Information Bulletin

I.B. No: 020

Aircraft Type: T67B, T67C, T67M, T67M-MkII, T67M200, T67M260 and T67M260-T3A

Title: REDEFINITION OF WING WALKWAY AREA – MOD M899

**VIEW ON PORT WING WALKWAY
(STARBOARD OPPOSITE HAND)**

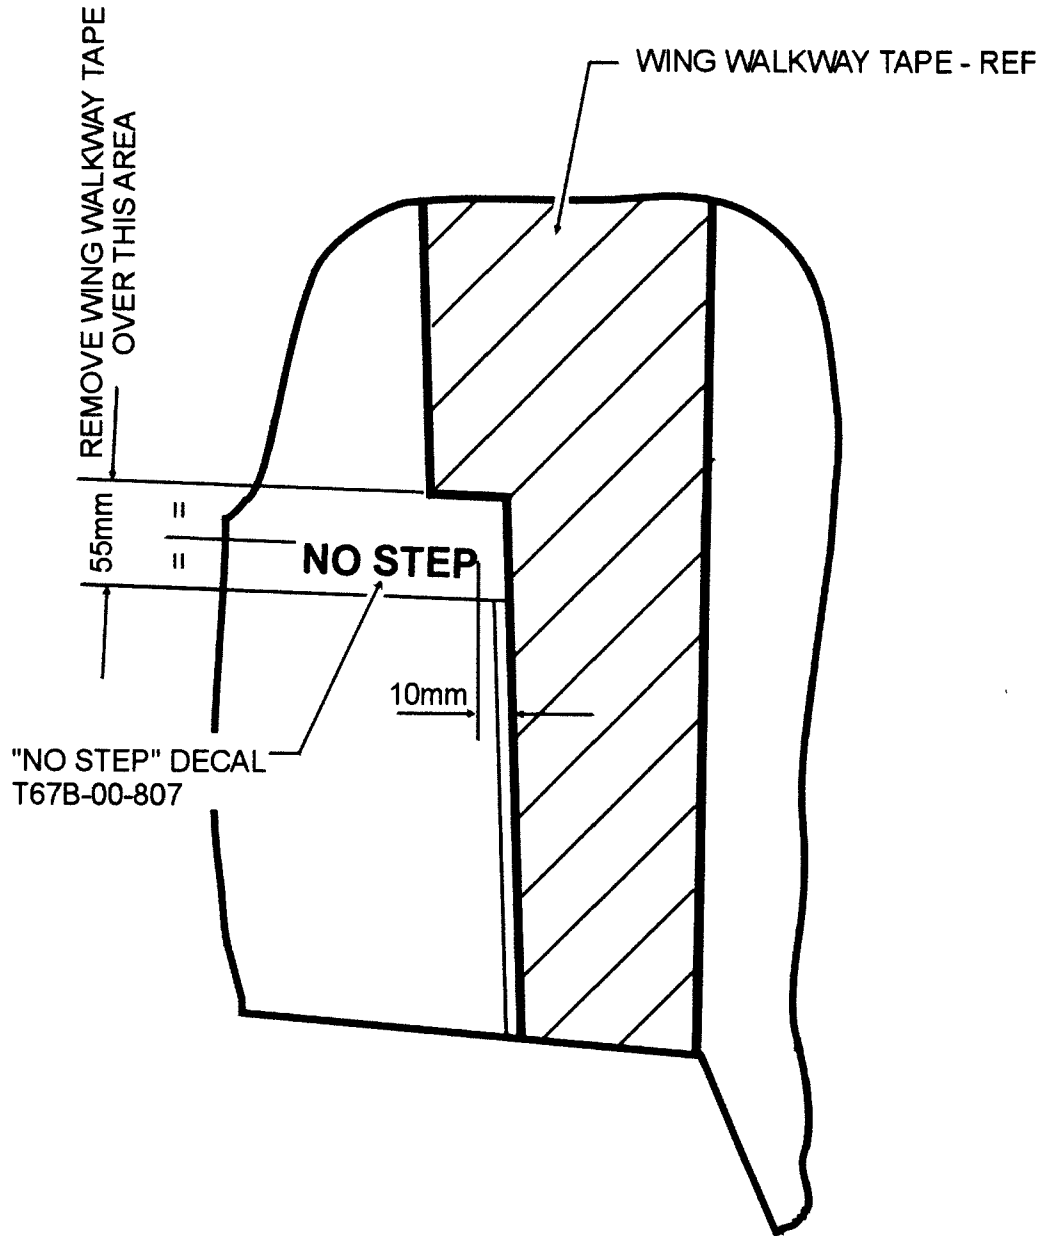
Slingsby have been informed of cracking of paint in the area above the rear spar adjacent to the wing walkway. Subsequent removal of the paint did not reveal any further damage.

The cause has been attributed to the possibility of personnel inadvertently standing outside the designated wing walkway area. In addition, during investigation by Slingsby, it was noticed that the walkway does extend over a relatively unsupported area of the flap shroud and could, when stood on, induce paint cracks.

Therefore it is suggested that the wing walkway area tape may be carefully removed as shown in Fig. 1. Ensure no damage to skin and restore paint finish. A "NO STEP" placard is to be painted on or fitted. A suitable placard is available from SAL as Part No. T67B-00-807. The implementation of this modification to be annotated in aircraft logbook as "Mod M899 incorporated".
